May 6, 2024

**RE: US Market Gas Station at 2115 Molalla Road (CU 24-01, DR 24-01, and ZA 24-01) Completeness Response**

RE: Status of CU 24-01, DR 24-01, & ZA 24-01 "US Market gas station" at 2115 Molalla Rd (Tax Lots 051W09B001000, 1100, & 1200 [primary])

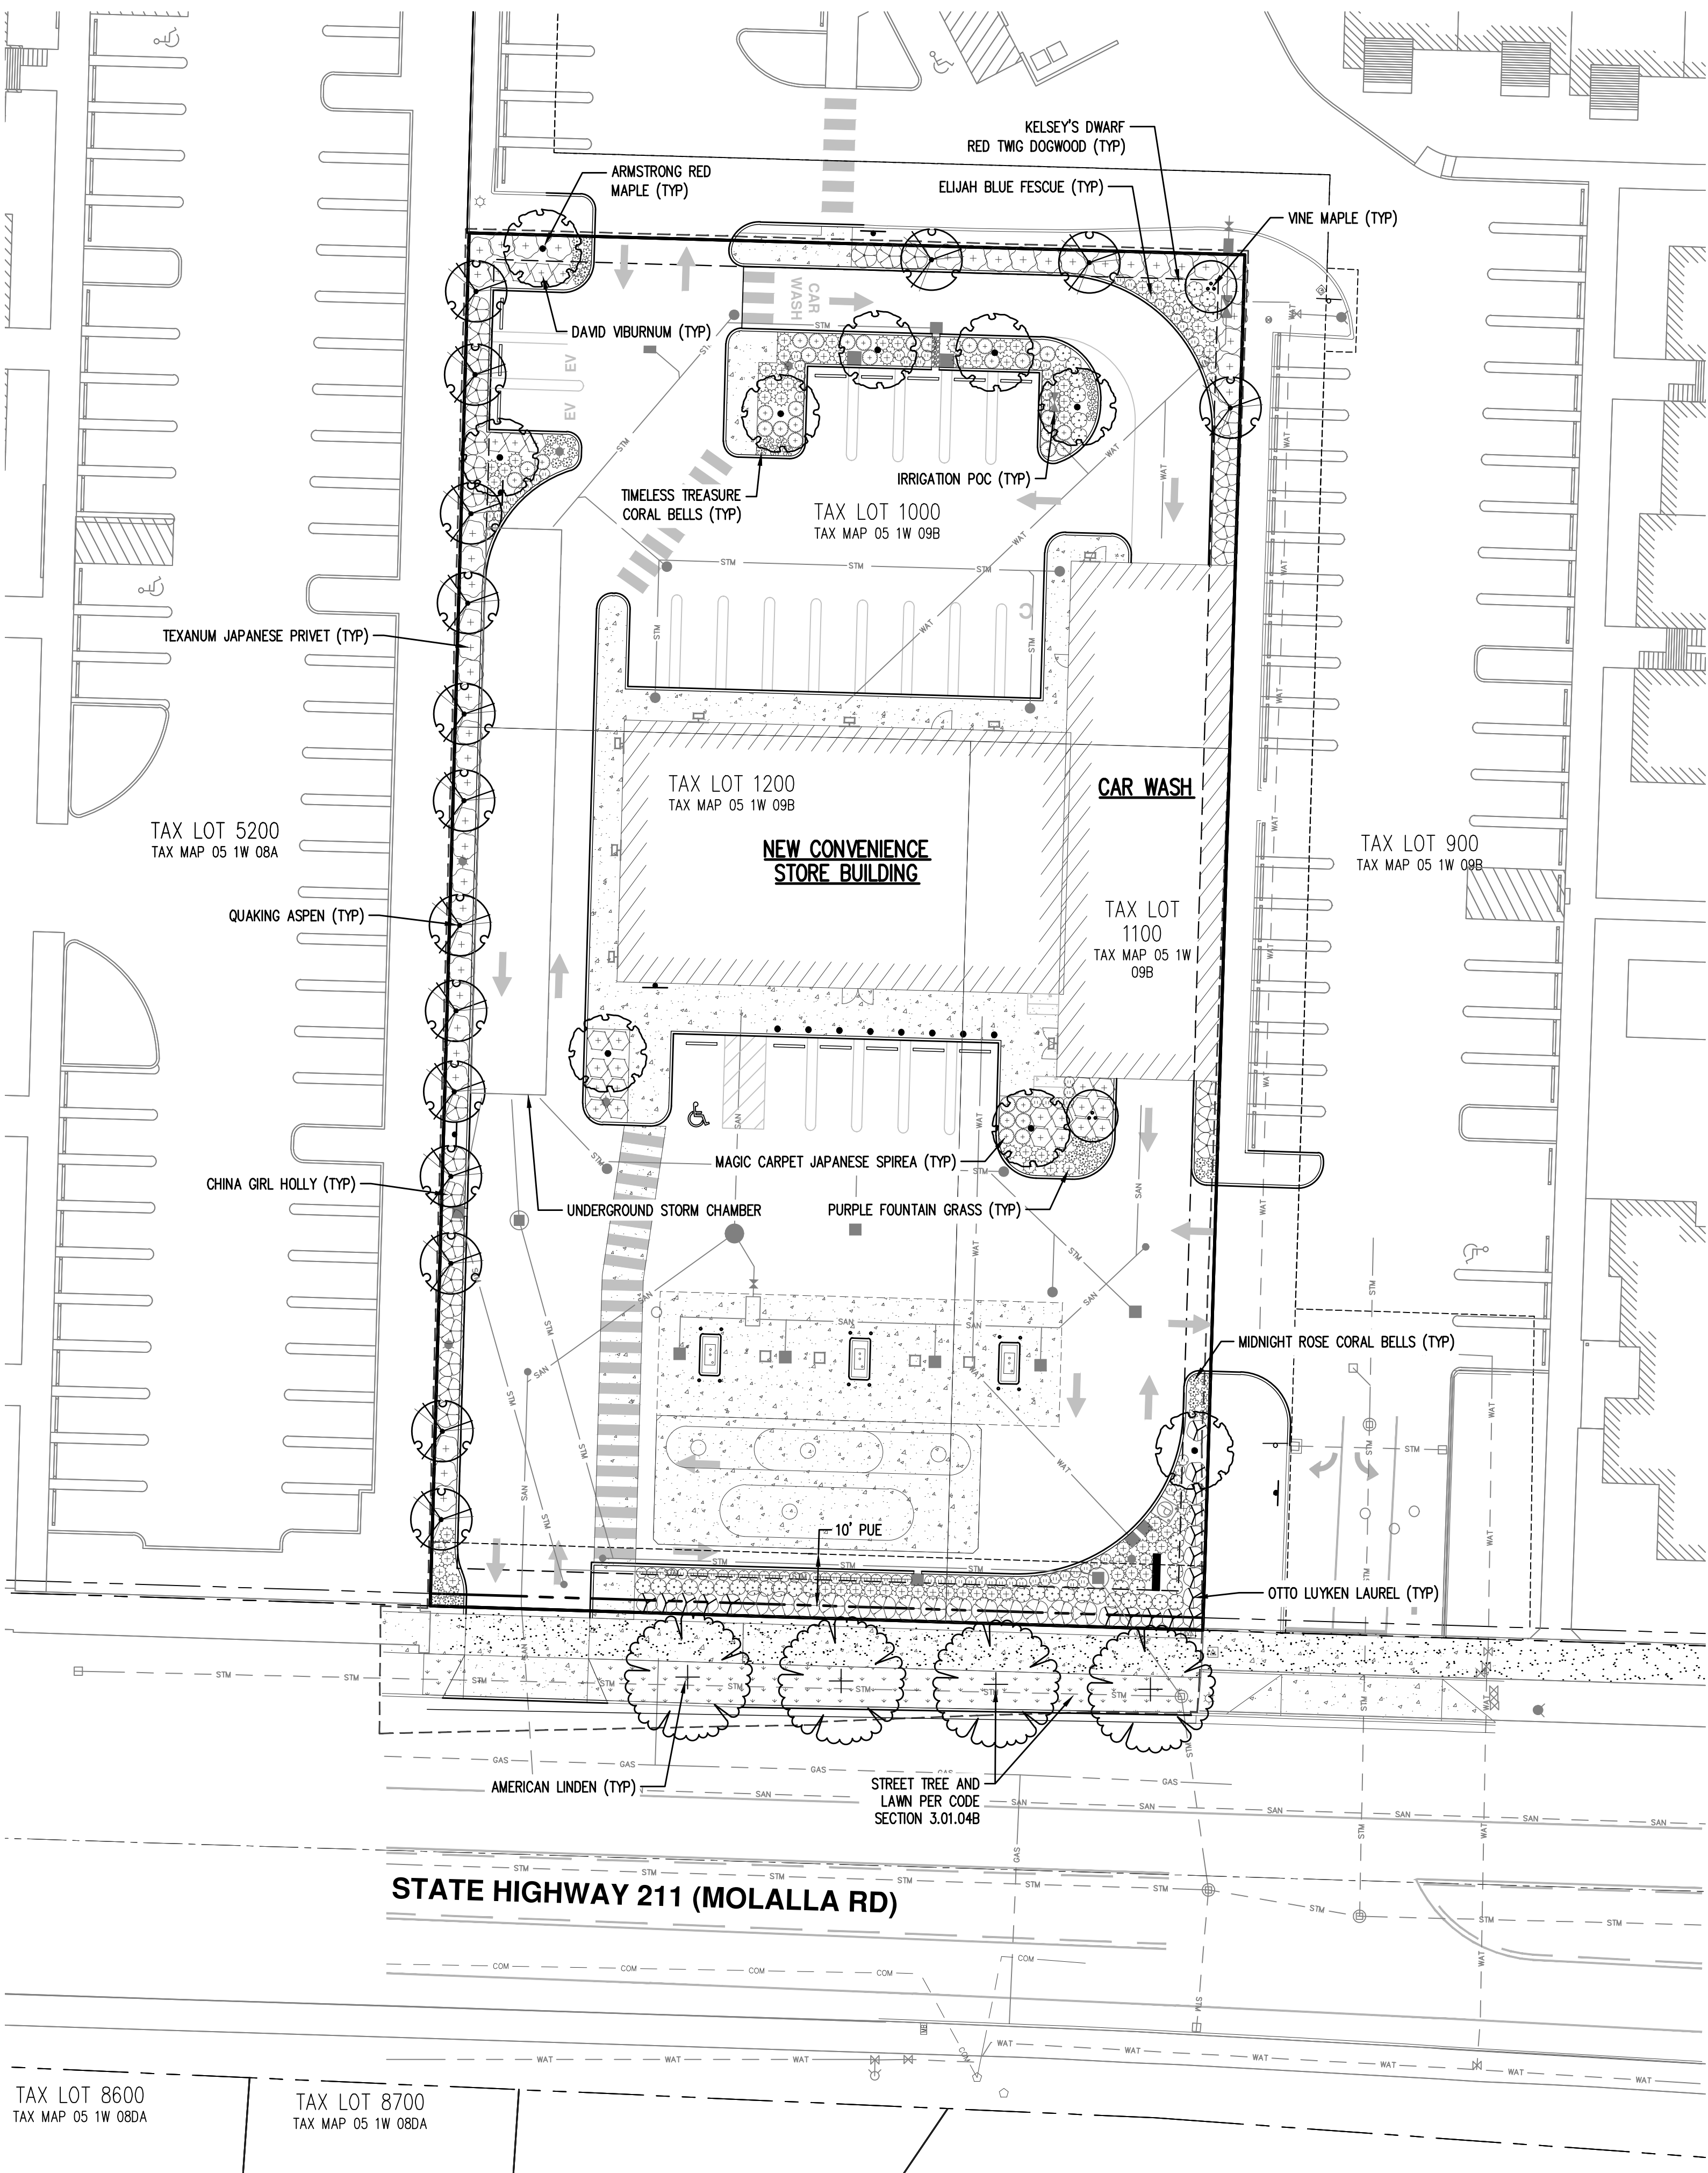
**B. Frontage/street improvements: Revise the Sheet L100 landscape plan to:**

1. *Indicate in the legend for each tree species either the size category at maturity as Table 3.06B describes or height in feet at maturity.*

*The revised landscape plan (Sheet L100) illustrates and notes the proposed street [tree] species as one reaching a mature height of 45 to 50 feet (ft). WDO Table 3.06B row 3 defines medium size category at maturity as 40-60 ft height.*

*3.06.03A.2a requires along the highway, which is "Major Arterial" class, large trees. Table 3.06B row 2 defines these as 60-120 ft height.*

*Revise the street tree species to a large one.*

**Response:** The Preliminary Landscape Plan has been revised as requested above. Refer to Sheet L100 in the revised Preliminary Land Use Plans in Attachment 1. This item is complete.

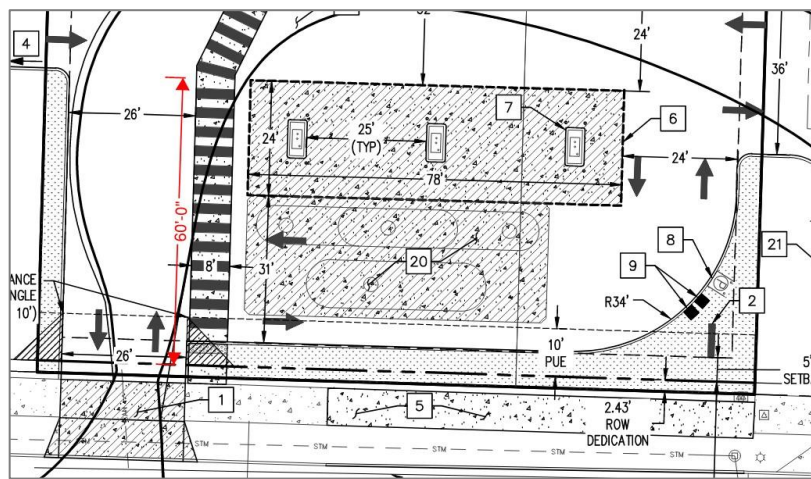
*O. Queueing: There appears too little room for vehicle queues at the pumps, and the application materials lack information about how queueing and circulation would operate. Guiding questions include:*

- 1. Is queueing one way?*
- 2. Are some pumps allocated for self-serve and others for attendant service or "mini serve"?*
- 3. What signage and striping should the site plans illustrate and note to describe intended queueing?*
- 4. How is queueing handled in the field during operations?*
- 5. What would prevent queued vehicles from backing up onto the highway?*
- 6. Because the site plan indicates no attendant booth, where and how would the attendant(s) be stationed?*

The response doesn't address the item and guiding questions, particularly Question 3.

**C100**

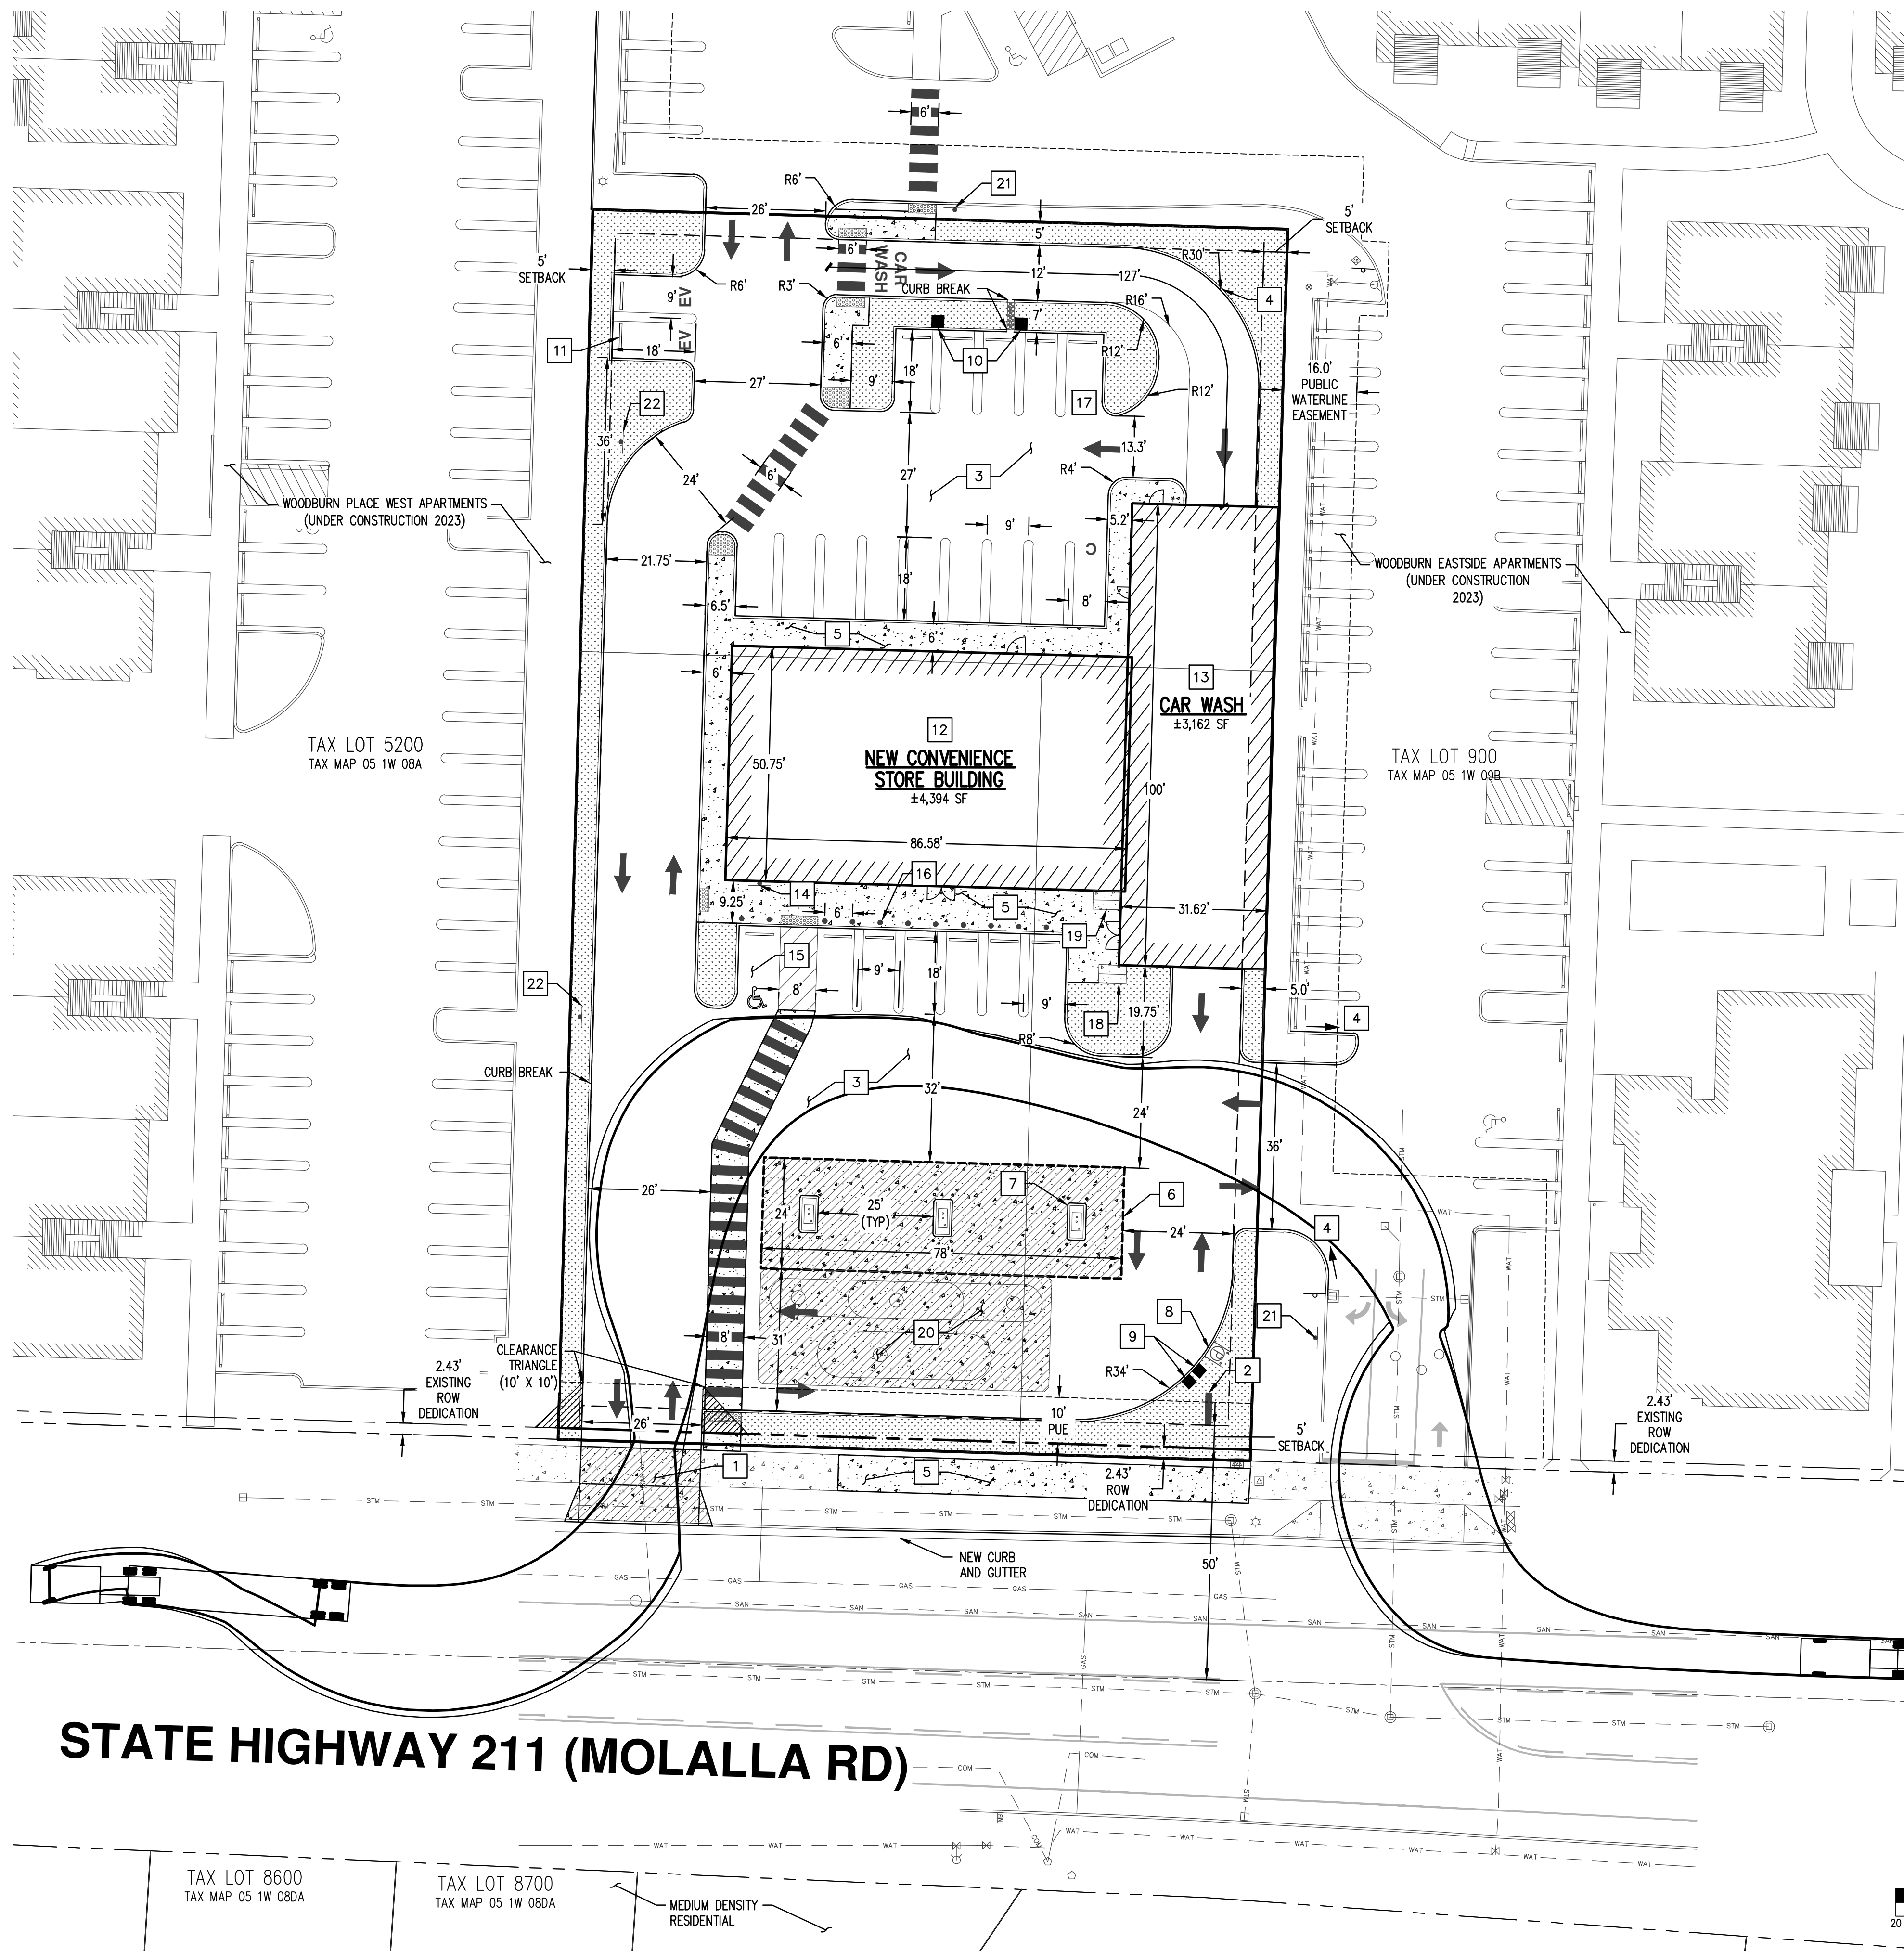
### *D. Driveway: Regarding the proposed driveway at 26 feet width:*

- 1. Submit Woodburn Fire District documentation allowing the developer to make use of Table 3.04A footnote 7 and revise the narrative under 3.04.04 to refer to the documentation.*

The site plan (Sheet C100) illustrates turning movement that doesn’t need 26 ft of width, and in any case the description above doesn’t affect the applicability of the WDO standard.

Note: Zoning Adjustment (ZA) of maximum driveway width to 26 ft is permissible per 5.02.06C.19c – with a [ZA application](#) including a revised [uniform application form](#), ZA fee payment of \$3,520 per the [Planning Division fee schedule](#), and application materials that address the factors and meet the criteria of 5.02.06B; however, staff doesn’t see how a proposal could meet criteria 1, 3, & 5 and would be disinclined to recommend approval.

Revise the site plans (or apply for ZA).

*I. Walkway islands/peninsulas: To conform with 3.06.03C.4, revise the site and landscape plans to provide a landscaped island or peninsula along the west side of the wide walkway where it passes through the parking aisle at the convenience store. (Revision could change the walkway alignment.)*

The description above doesn't affect the applicability of the WDO standard.

Revise the site plans (or apply for a variance).
